F/CMVSS Noncompliance Recall

N222363740 Headlight Reflection May Cause Glare

Release Date: August 2022

6102470

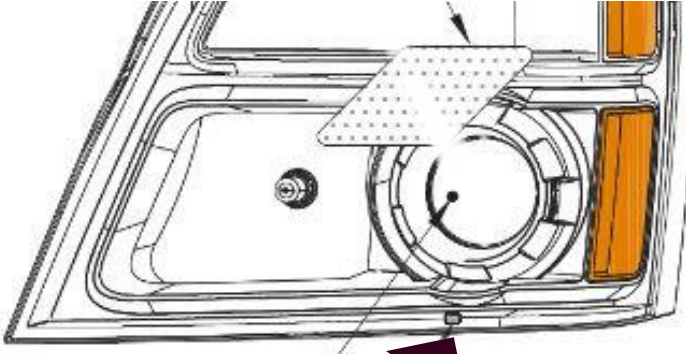
- 2.1. Align the bottom edge of the template to the bottom of the headlamp.

6102471

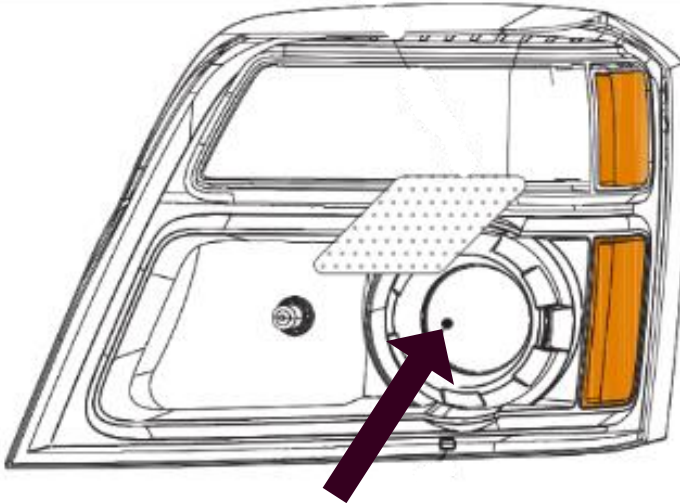
2.2. View the H11 lens marking in the square cut out.

6102472

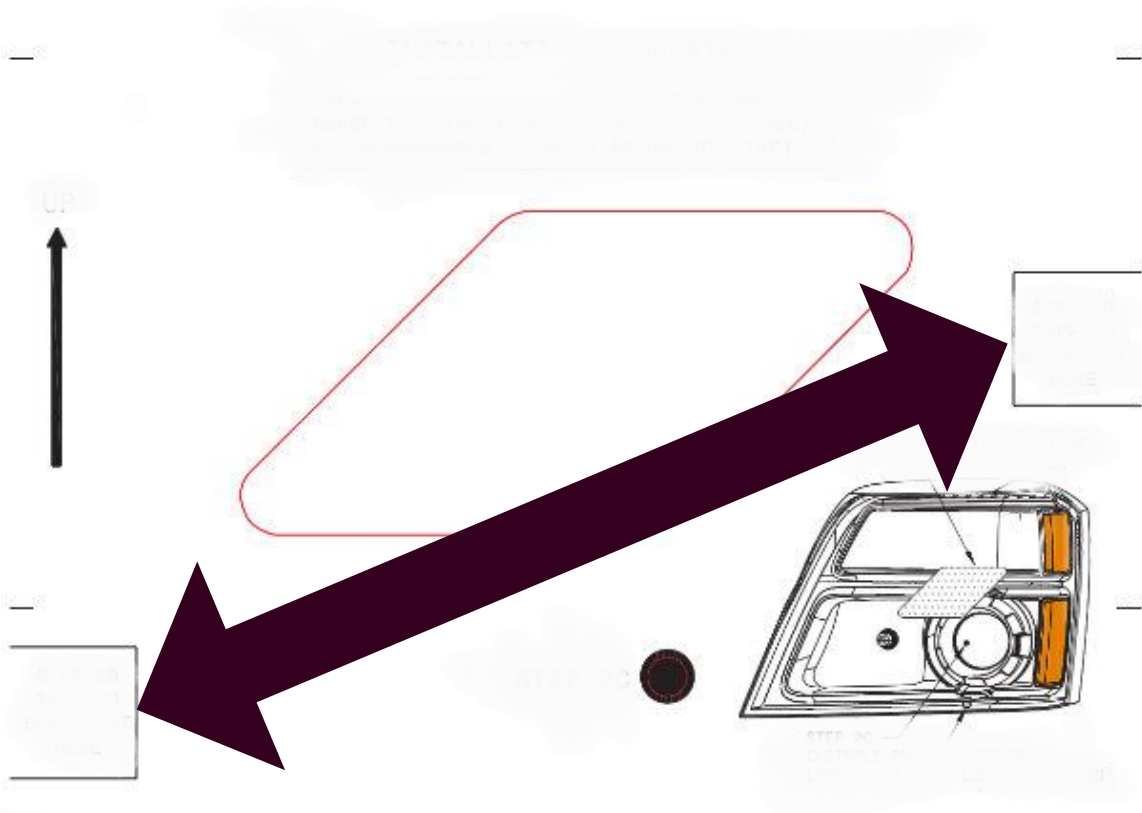
2.3. Center the circle cutout over the dimple on the lens/cover.

6102476

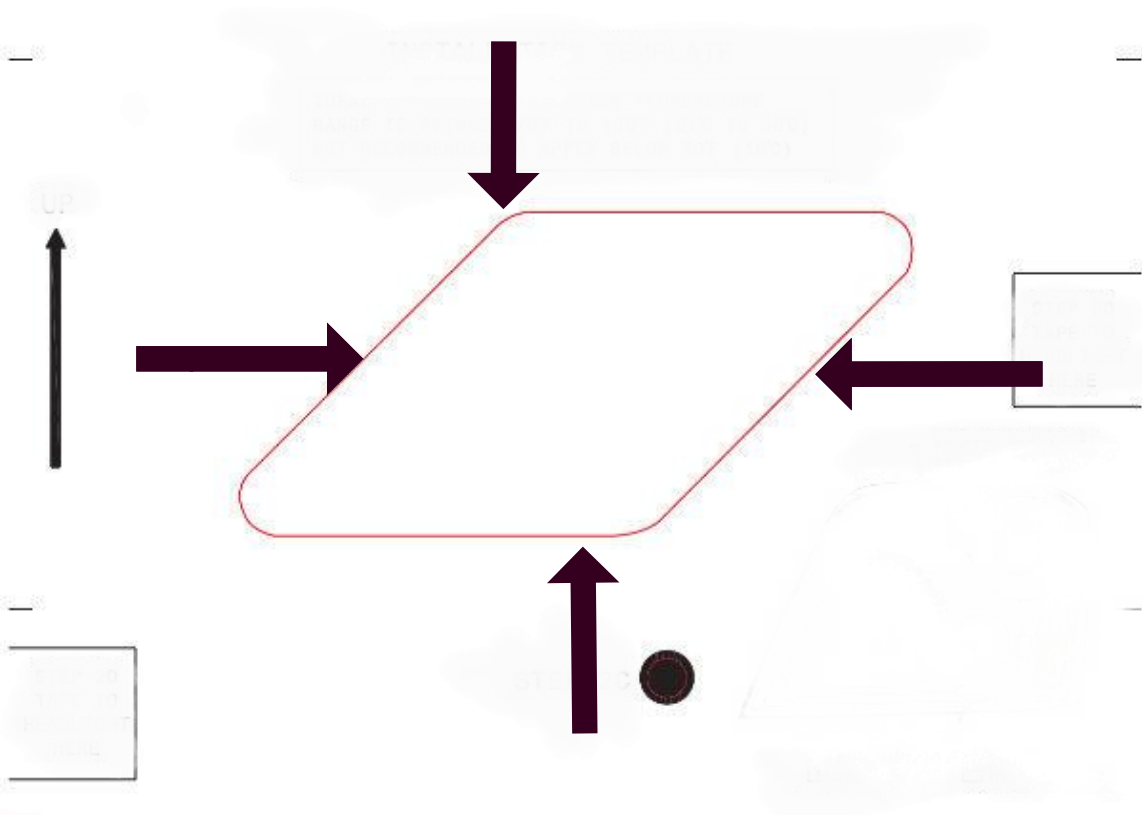
2.4. Use tape to secure template in two places as marked.

6102483

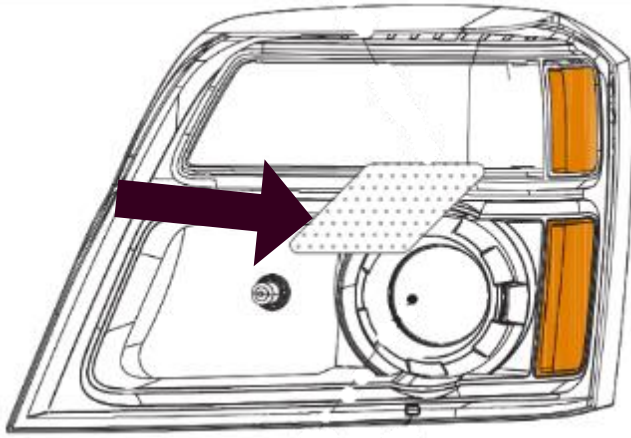
3. Remove the backing from the frosted applique before installing (do not touch adhesive on backside).

- Center the applique in the large cutout in the template.
- Apply even pressure over the entire applique pressing out all bubbles.
